Access Compliance Report Public Rights-of-Way (Curb Ramps)

Main Street: **CHIRPING_SPARROW_WAY** Cross Street: **BENT_TWIG_LN** Location: **E**

ADA ID: **RPRK220103142334** Ramp Type: **Type 1 - Perpendicular Diagonal Initial Pass/Fail: Pass** Overall Compliance: **No** Severity Score: **4**

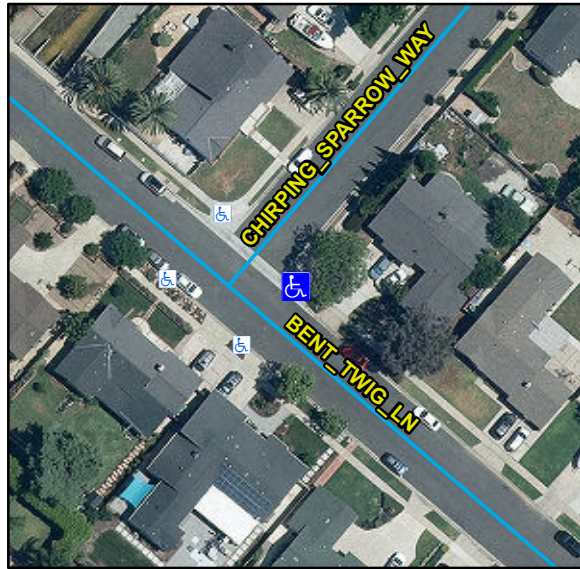
Compliance	Description	Data	Compliance	Description	Data
N/A	Ramp Length (in)	89	N/A	Flare Type LT	
Yes	Ramp Width (in)	48			Sloped
Yes	Ramp Run Slope (%)	2.3	N/A	Flare Slope LT (%)	5.7
Yes	Ramp Cross Slope (%)	0.4	N/A	Flare Traversable LT	No
N/A	Landing Present	Yes	N/A	Flare Type RT	
N/A	Landing Length (in)	44			Sloped
Yes	Landing Width (in)	48	N/A	Flare Slope RT (%)	6.5
No	Landing Run Slope (%)	2.5	N/A	Flare Traversable RT	No
Yes	Landing Cross Slope (%)	0.6	Yes	DWS Provided	Yes
N/A	Landing Movement Obstructed?	Yes	Yes	DWS Contrast	Yes
	Landing Movement Type	Curb	Yes	DWS Length (in)	36
N/A	Landing Shared	No	Yes	DWS Full Width	Yes
N/A	Clear Space	Yes	Yes	DWS Offset Left (in)	2
N/A	Clear Space To Crosswalk (in)	48	Yes	DWS Offset Right (in)	N/A
N/A	Marked Crosswalk 1	No	N/A	Marked Crosswalk 2	No
	Crossing 1 Direction	NE		Crossing 2 Direction	NW
	Marked Crosswalk 1 Width (in)	N/A		Marked Crosswalk 2 Width (in)	N/A

Remove & Replace Landing.
